M3 UAX Steering Linkage Service Notice:

M-3 UAX steering rod service issue

date: 2008/09/19

Steering rod extension.

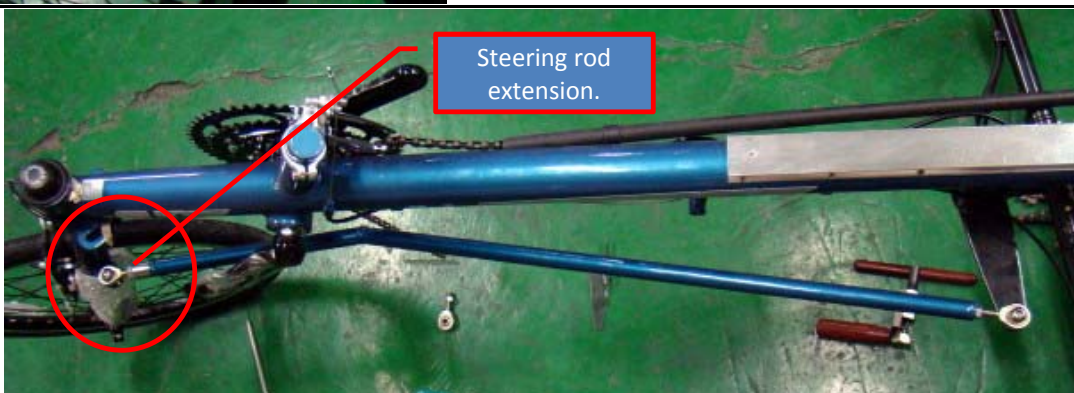
Due to an error at the factory, the steering linkage was made too short. In order to correct the problem attach the 20mm extension to the front end of the rod.
